MS90 Audio & USB Daughter Board Block Diagram

FOXCONN		HON HAI Precision Ind. Co., Ltd. CCPBG - R&D Division
Title	Block Diagram	
Size	Document Number	Rev
Custom	MS90-1-02	1.0
Date	Friday, March 23, 2007	Sheet 2 of 10

FOXCONN		HON HAI Precision Ind. Co., Ltd.	
Title		History (1)	
Size	Document Number	Rev	
A3	MS90-1-02	1.0	
Date:	Friday, March 23, 2007	Sheet	9 of 10

FOXCONN		HON HAI PRECISION IND. CO., LTD.	
Title		CPBG - R&D Division	
USB2.0 & 6 pin conn			
Size	Document Number	Rev	
43	MS90-1-02	1.0	
Date:	Friday, March 23, 2007	Sheet	3 of 10

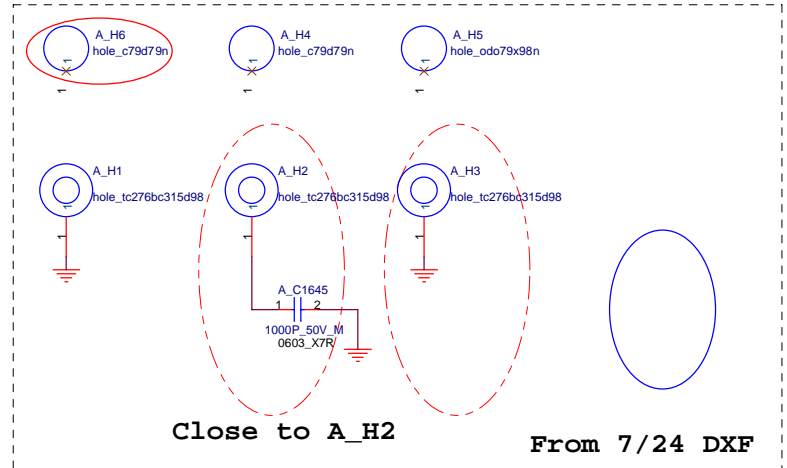
P.03 Modify USB connector A_CN28,A_CN37 for M/E suggest.

P.03 Adding screw A_H1~A_H4 from ME request.

P.03 Add A_JPSK2 to MIC board connector.

P.03 Change A_JSPK2 to FOX_HS8804F from ME request.

P.03 Remove A_H4 from ME request.

P.03 Add A_C327~A_C329 for EMI request.

P.03 Change A_JPSK2 to FOX_HS8805F for ME request.

P.03 Change A_JPSK2 to HS8806F for ME request.

P.03 Change A_CN1 to QTS0040A for ME request.

P.03 Add A_R1392,A_R1393 for VDDA & +5VRUN option.

P.03 Add A_R1994,A_R1995 for GND & A_GND option.

P.03 Update A_CN1 for ME

P.03 Swap the A_CN1 pin assign for layout

P.03 connect pin #2 of A_C217 to pin #1 of A_JPSK2.

P.03 Del A_JPSK2 pin7 of A_GND for layout plane.

P.03 A_CN28,A_CN32 change from UB11123-C1601-FR to UB1112C-CA501-7R for ME

P.03 A_CN28,A_CN32 change from UB1112C-CA501-7R to UB11123-C1601-FR for ME

- P.03 A_H2 change from GND to A_GND for EMI suggest.
- P.03 A_C1645 connect GND to A_GND for EMI suggest.
- P.03 A_CN37,A_CN28 change to UB11193-C1304-4F for ME suggest.

- P.03 Add A_H4,A_H5 for ME fix hole.

- P.03 A_R1390 pin 1 change from GND to A_H3 pin 1 for EMI suggest.

- P.03 Del A_R2001,A_R1390, and add A_C1645,A_C1646 for EMI (close to A_H3,A_H2).
- P.04 A_R1388 change from stuff to NC for GND & A_GND should be one point.
- P.06 Del A_R1391, and add A_C1647 for EMI (close to between USB conn and Mic jack).

- P.03 Del A_C1646 for A_H3.
- P.05/06 Update A_CON2,A_CON3 footprint for PIH.

- P.03 Change A_CN28 A_CN37 from UB11193-C1304-4F to UB11193-C1314-4F for ME request modify connector color.
- P.05 Change A_CAP22,A_CAP23 vendor from LELON to NICHICON because LELON raw material not from GP vendor.

Title	AUDIO(CODEC & POWER)		
Size	Document Number		Rev
A3	MS90-1-02		1.0
Date:	Friday, March 23, 2007	Sheet	4 of 10

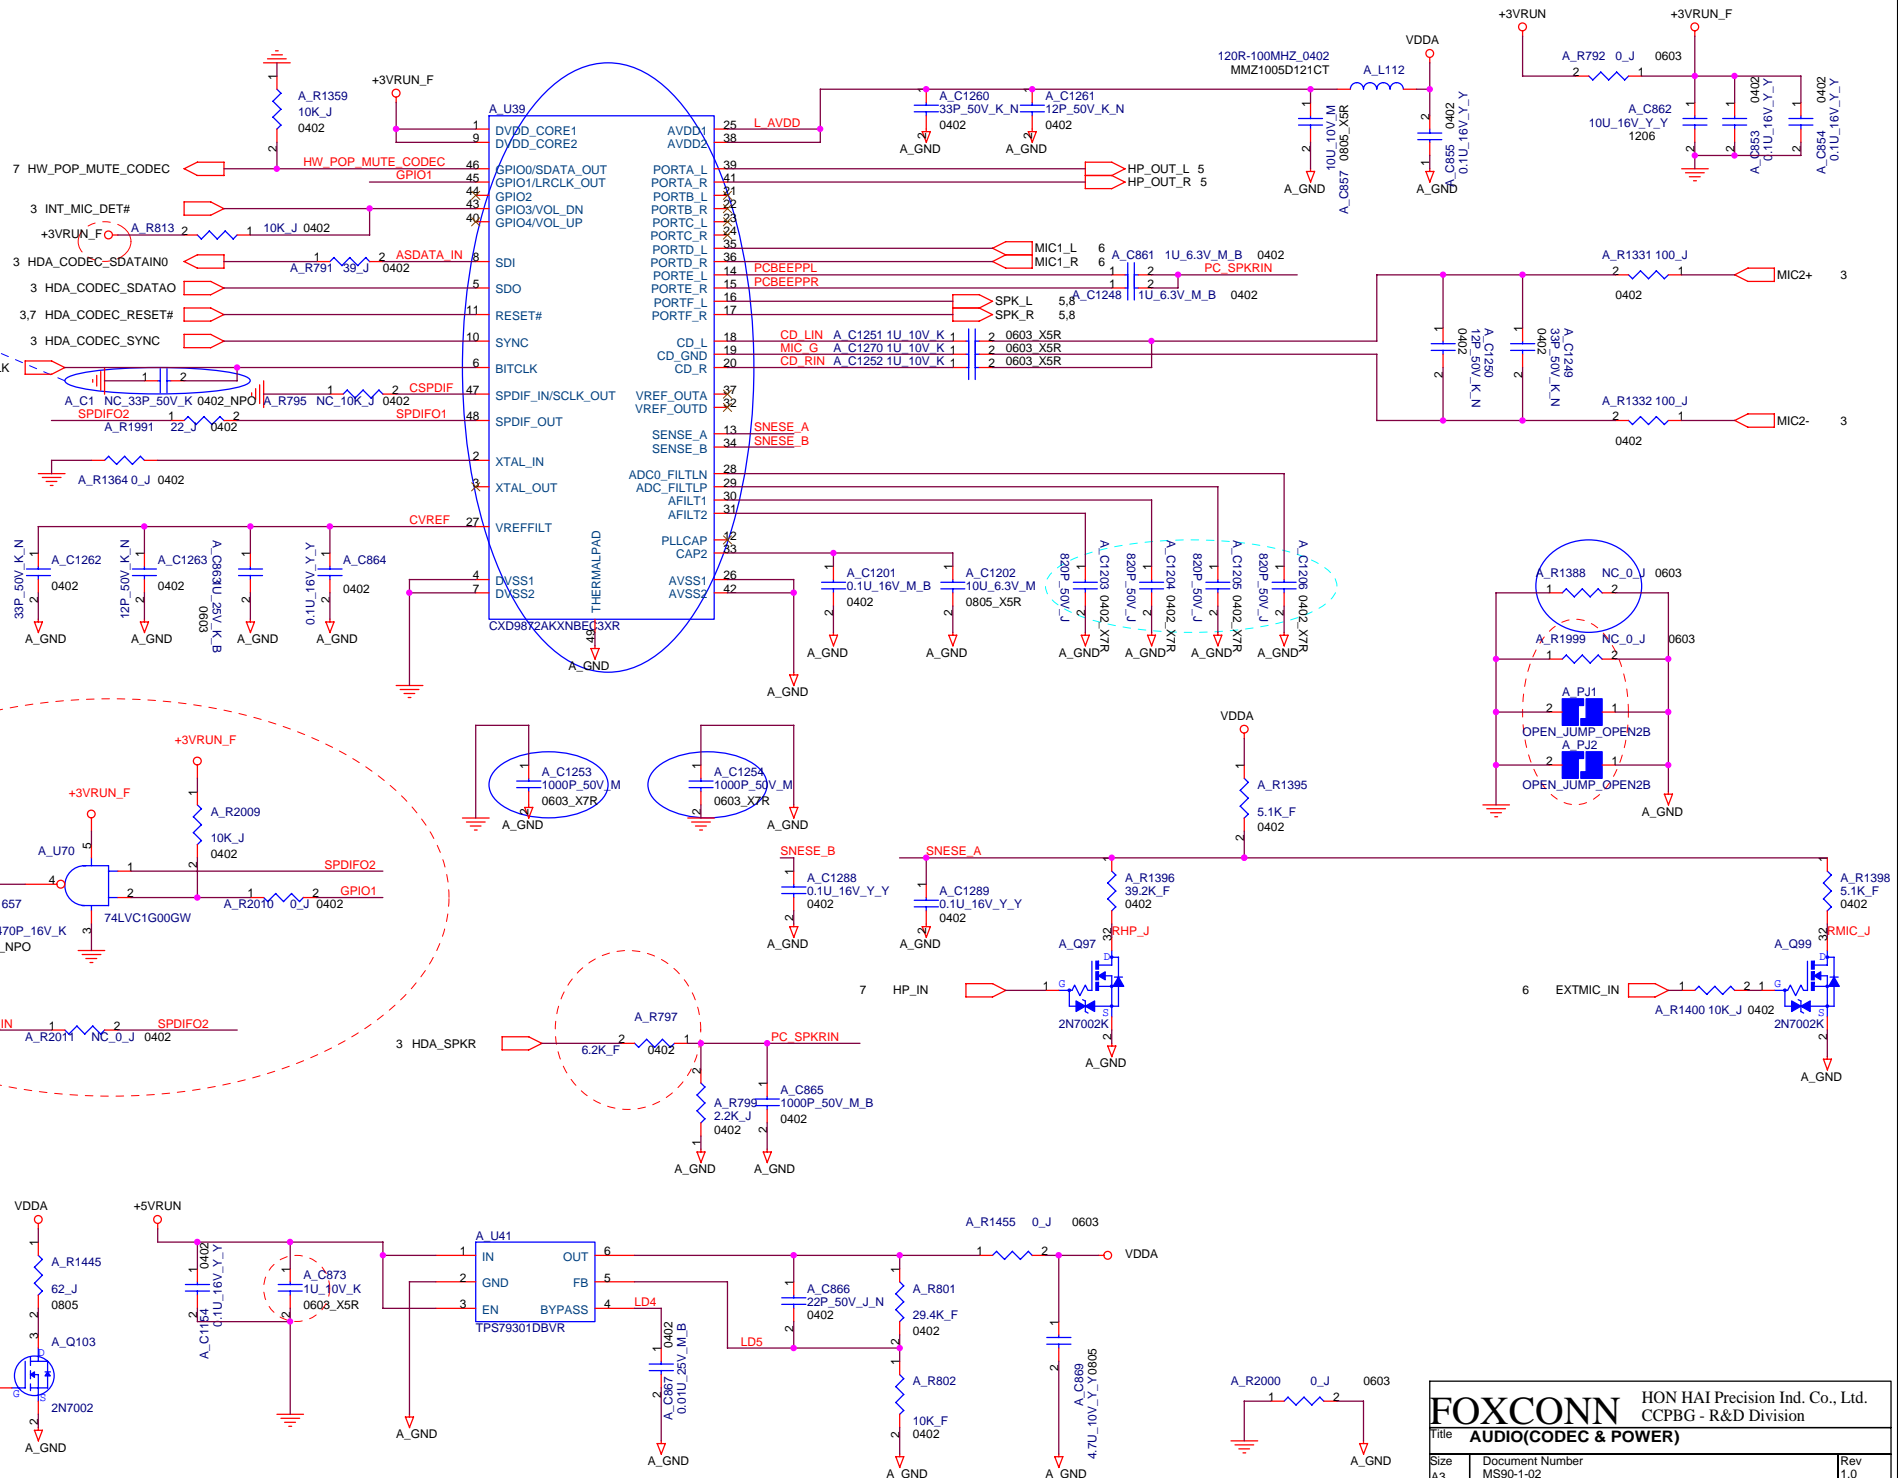
P.04 Change A_U39 CXD9872AKD to CXD9872AK from MOR suggest.
P.5,6 Modify A_CON2,A_CON3 connector from ME suggest.

P.04 Pin name INT_MIC_DET connect to codec (Pin44)

P.04 Add A_R813 pull up VDDA for INT_MIC_DET

P.03/04 Modify INT_MIC_DET pin name to INT_MIC_DET#, and change from GPIO2(Pin 44) to GPIO3 (Pin 43) for MOR suggest

P.04 Change A_U39 to CXD9872AKXNBEC3XR because HH P/N error.

P.04 Change signal name MIC2_L/MIC2_R to MIC+/MIC- .

P.04 Reserve A_C1 from EMI request.

P.04 Add A_GP4,A_GP5 close jump from MOR suggest.

P.04 Change A_C1 value to stuff.

P.04 Change A_R1388 0402 to 0603 for EMI request.

P.04 Change A_C1253,A_C1254 33P to 1000P for EMI request.

P.04 Delete A_CN38 connector.

P.04 Modify A_U42 power net & A_R1360.1 VDDA to +5VAMP for A_U42 power supply.

P.04 A_Q104 pin2 change from MUTE_TR to HP_IN_DET.

P.04 Sub-woofer of Ground change from A_GND to GND.

P.04 Del AUDIO_INPUT pin name (A_U39 pin21/22).

P.04 Add resistor A_R1403, A_1404 for Sub-woofer input.

P.04 Del CB_SPKOUT# net name to GND for PC_SPKRIN.

- P.04 Del A_GP3,A_GP4,A_GP5 (Close GP)
Add A_PJ1,,A_PJ2 (Open GP), A_R1999 for MOR suggest.
- P.05 A_D70 change from stuff to NC for EMI suggest.
- P.05 A_CAP22,A_CAP23 change from UWR0J221MCL1GB to VE2-6V221MF55-R.
- P.04 Add A_R2000 connect to GND and A_GND close to A_U41 for MOR suggest.
- P.03 Add A_R2001 to GND for EMI suggest.
- P.03 Del A_C1645 for EMI suggest.

- P.04 A_C873 1uF change from 0805 to 0603 for +5VRUN.

- P.04 A_C1 change from stuff to NC for low phase of BCLK timing.

- P.04 Del A_U40,A_C1290 for HDA_SPKR.
- P.04 A_R797 change from 10Kohm to 6.2Kohm for HDA_SPKR.

- P.04 A_C1203,A_C1204,A_C1205,A_C1206 change from X7R to NPO for MOR suggest.
- P.05 Del A_C877 for +5VAMP.

- P.04 Add A_U70,A_R2009,A_C1657,A_GP1 for SPDIF_IN
- P.04 Change A_C1203-A_C1206 from NPO to X7R for PUR convenient.

- P.04 A_U70 change from 74AHC1G00GW to 74LVC1G00GW.
- P.04 Del A_GP1, Add A_R2010 for SPDIF_IN.
- P.04 A_C1657 change from stuff to NC for HDMI audio noise issue.

- P.04 Add A_R2011 for option SPDIF_IN.

FOXCONN		HON HAI Precision Ind. Co., Ltd.	
		CCPBG - R & D Division	
Title AUDIO(AMP & HP & SPK)			
Size	Document Number	Rev	
A3	MS90-1-02	1.0	
Date:	Friday, March 23, 2007	Sheet	5 of 10

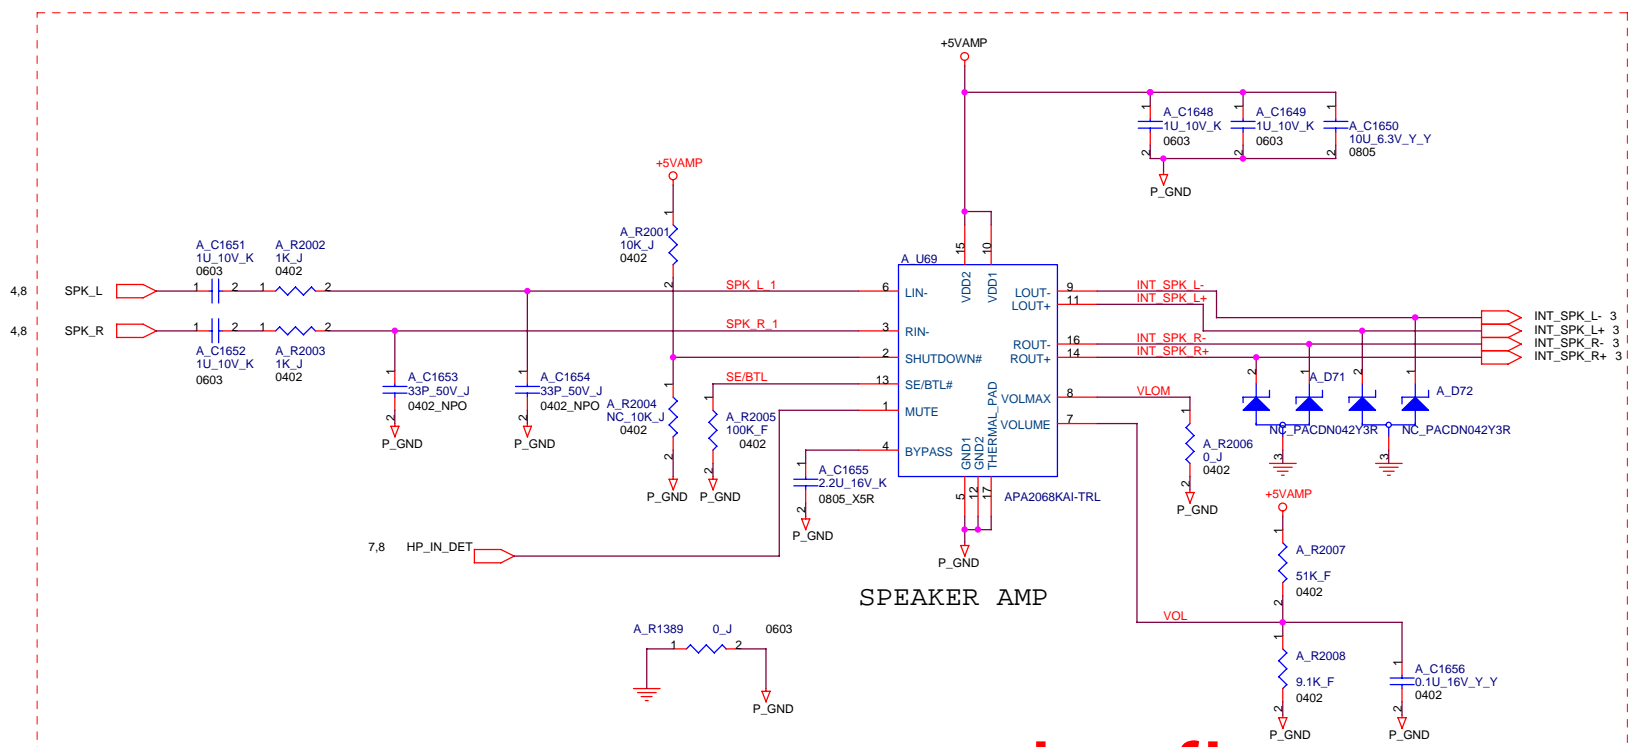
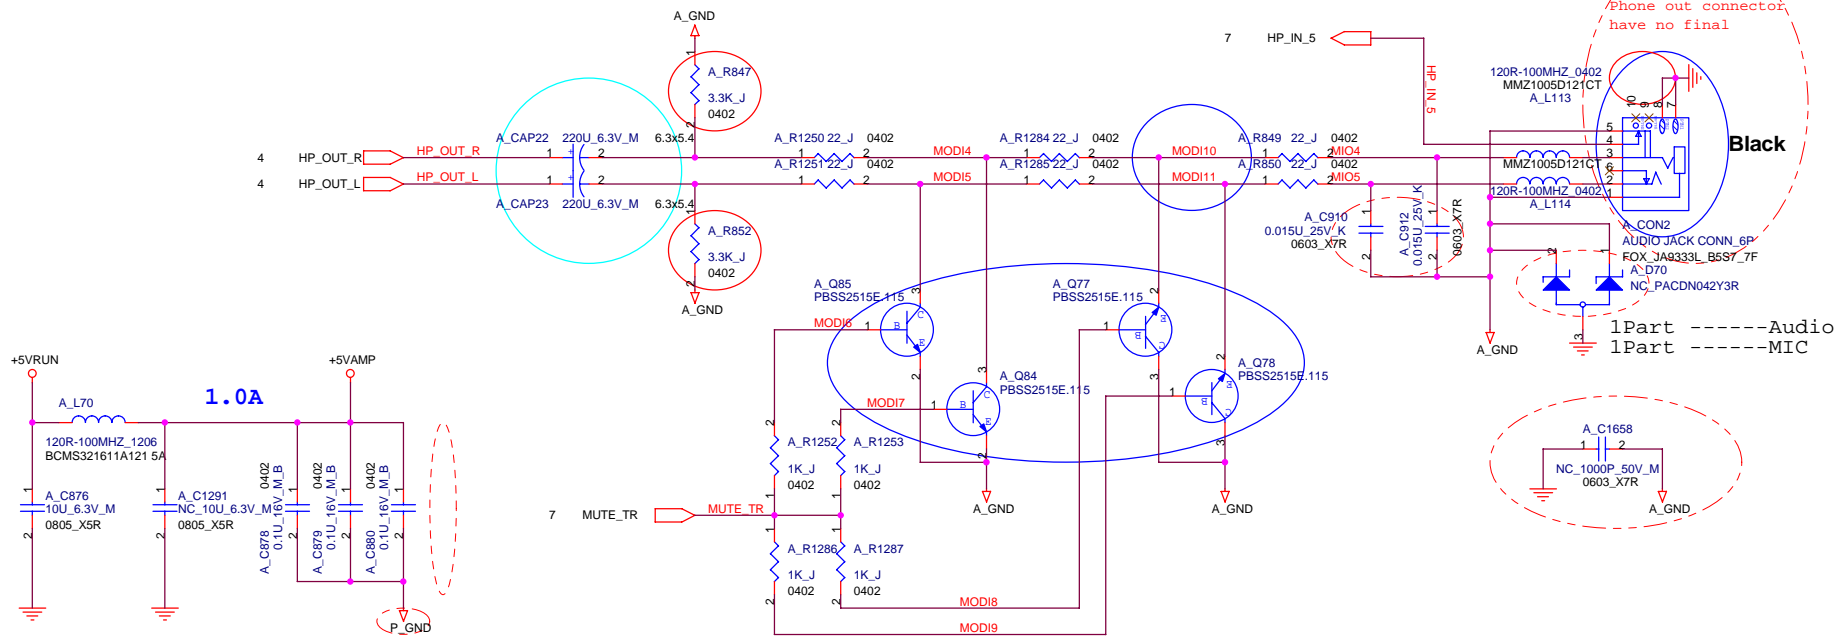
P.05 Modify internal speaker AMP gain setting,change A_R1970,A_R1971 from 4.7K (AMP output 1.12W) to 5.1Kohm(AMP output0.98W) to fit in speaker (1.0W)spec.

P.05 Add pin name MODI10 near A_R849(Pin 1)

P.05 Add pin name MODI11 near A_R850(Pin 1)

P.05 Swap the polarity order of mute Tr to improve mute function. That is to connect MODI4 to pin #3 of A_Q84, MODI5 to pin #3 of A_Q85, and MODI10 to pin #2 of A_Q77,MODI11 to pin #2 of A_Q78

P.05 A_U66(Amp. TPA6011A4PWPRG4) of ground change from A_GND to P_GND.

P.05 Add A_R1389 connect P_GND of +5VAMP and GND.

P.05 Add A_R1390 connect GND and A_GND for phone out connector.

P.05 A_R1389 change from NC to stuff for floating issue.

P.05 A_CAP22,A_CAP23 change from 1C-42T0107-M100 to 1C-10U0227-M100 for Audio phone out (Output CAP.)

P.05 A_C910,A_C911 change from 0.033uF to 0.015uF for vista spec.

P.05 A_CON2 change from JA9333L-G5S7-7F(Green) to JA9333L_B5S7_7F(Black)

- P.05 A_R847, A_R852 change from 10Kohm to 3.3Kohm for PoP noise.
- P.06 A_CON3 change from JA9333L-R1S9-7F to JA9333L-R1M9-7F for ME request.

- P.05 A_C910,A_C912 change from 1C-2B30153-M000 (0.015uF,25V,20%,0603) to 1C-2B30153-K000 (0.015uF,25V,10%,0603)

- P.05 A_CON2 change from JA93331-G1S9-7F to JA9333L-B1M9-7F for ME suggest.
- P.05 Amplifier change TI (TPA6011A4PWPRG4) to Anpec (APA2068KAI-TRL).
- (1) Del A_U66,A_C1093,A_C1092,A_C1227,A_C1229,A_C1198,A_C1226,A_C1225,A_C1264,A_C1265,A_C1266(NC),A_C1267(NC),A_C1268(NC),A_C1269(NC),A_R1970,A_R1971,A_R1366,A_R1365,A_R1367,A_R1368.
- (2) Add A_U69,A_C1651,A_C1652,A_C1653,A_C1654,A_C1655,A_C1656,A_C1648,A_C1649,A_C1650,A_R2002,A_R2003,A_R2001,A_R2004,A_R2005,A_R2006,A_R2007,A_R2008,A_D71(NC),A_D72(NC).

- P.05 Add A_C1658 close to A_CON2 for EMI option.
- P.06 Add A_C1659 close to A_CON3 for EMI option.

FOXCONN		HON HAI Precision Ind. Co., Ltd.	
Title		AUDIO(EXT MIC & PHONE OUT)	
Size	Document Number	Rev	
A3	MS90-1-02	1.0	
Date:	Friday, March 23, 2007	Sheet	6 of 10

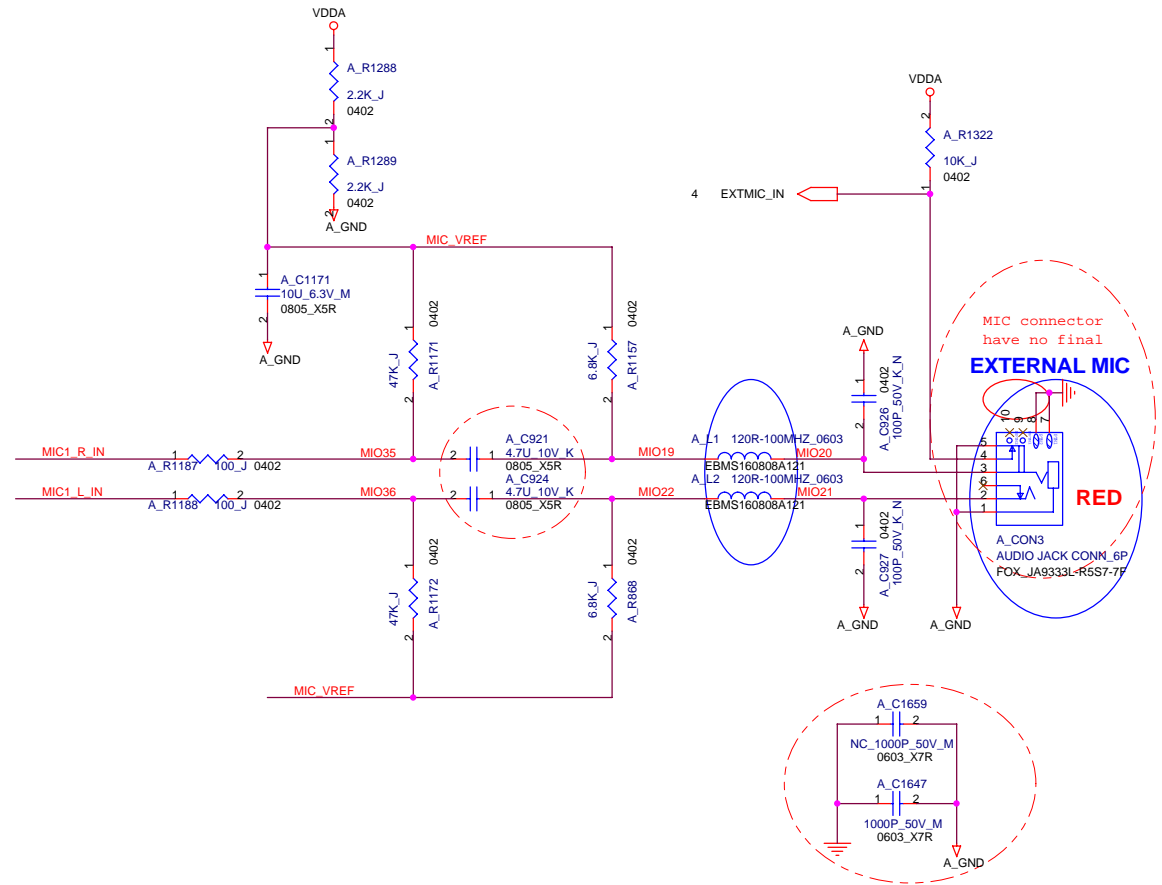
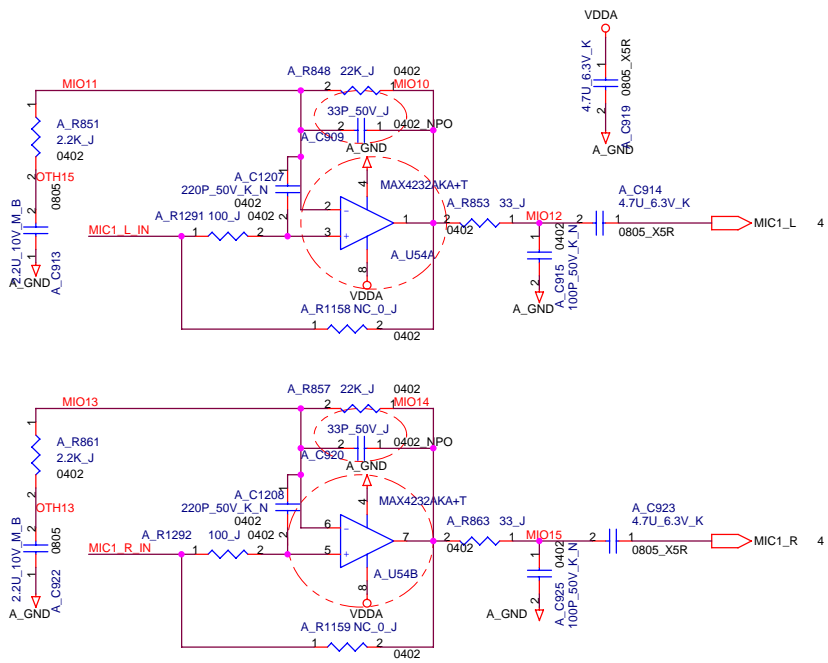
P.06 Remove A_R1037,A_R1038,add A_L1,A_L2 for EMI request.

P.06 A_C921,A_C924 change from 4.7uF/6.3V to 4.7uF/10V for MOR suggest.

P.06 Add A_R1391 connect GND of and A_GND for external MIC connector.

P.06 A_C909,A_C920 change from 220pF to 100pF for vista spec.

- P.05 A_CON2 change from FOX_JA9333L_B5S7_7F to FOX_JA93331-G1S9-7F for ME.
- P.06 A_CON3 change from FOX_JA9333L-R5S7-7F to FOX_JA9333L-R1S9-7F for ME.

- P.06 A_C909, A_C920 change from 100pF to 33pF for A-D Magnitude Response vista spec.
- P.08 Change Sub_woofer circuit from stuff to NI for cost down.
- P.05 A_CON2 Pin7/Pin8 change from GND to NC for HP CONN NPTH.
- P.06 A_CON3 Pin7/Pin8 change from GND to NC for External MIC CONN NPTH.
- P.08 A_C1644 change from 0.022uF 0402 to 0603.
- P.03 Add A_H6 for ME fix hole.
- P.03 Change A_JPSK2 to FOX_HS8106E from ME request.

- P.06 A_CON3 change from JA9333L-R1M9-7F to JA9333L-R5S7-7F for ME.
- P.05 A_CON2 change from JA9333L-B1M9-7F to JA9333L-B5S7-7F for ME.

FOXCONN		HON HAI Precision Ind. Co., Ltd.	
		CCPBG - R&D Division	
Title AUDIO (MUTE & INTMIC)			
Size	Document Number		Rev
A3	MS90-1-02		1.1
Date:	Wednesday, March 28, 2007	Sheet	7 of 10

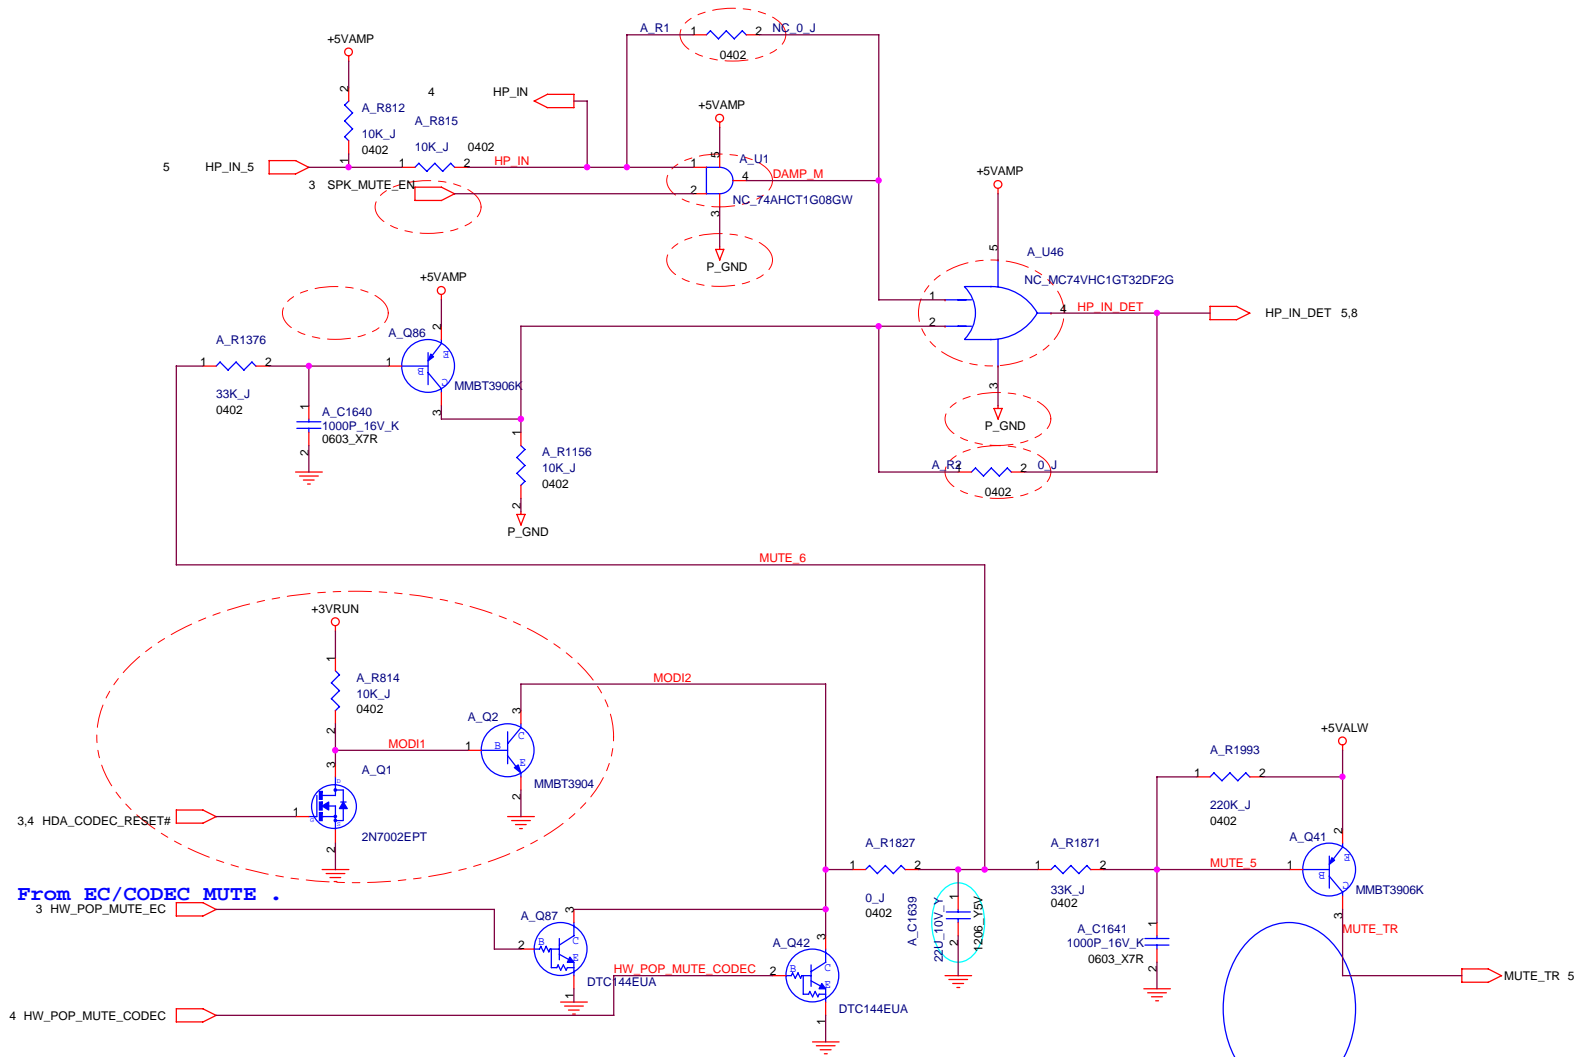
P.07 Del A_U45,A_U83

P.07 Add A_U1,A_U46,R1,R2

P.07 Add pin name SPK_MUTE_EN to EC

P.07 Del A_R1111 for no docking function

P.07 Del A_U50

P.07 Add A_R1827,A_R1871,A_R1992,A_R1993,A_C1639,A_C1640,A_C1641

P.07 A_R1376 Change from 10Kohm to 33Kohm

P.07 A_Q41 change from DTA114YUA to MMBT3906K

P.07 A_U1,A_U46 from stuff to NC for MOR suggest.

P.07 Del A_R1992,A_U103,A_D67,A_C1188,A_U104,A_R1370 for MOR suggest. (Ref:MS31/51)

P.07 Add A_Q1,A_Q2,A_R814 for MOR suggest. (Ref:MS31/51)

P.07 A_R2 change from NC to stuff for MOR suggest.

P.07 A_U1 Pin3 change from A_GND to P_GND for +5VAMP.

P.07 A_U46 Pin3 change from A_GND to P_GND for +5VAMP.

P.07 A_U1,A_U46 change from stuff to NC for MOR suggest.

P.07 A_R1996 change from stuff to NC for MOR suggest.

- P.07 Change A_C1639 from 10U to 22U for PoP noise issue.
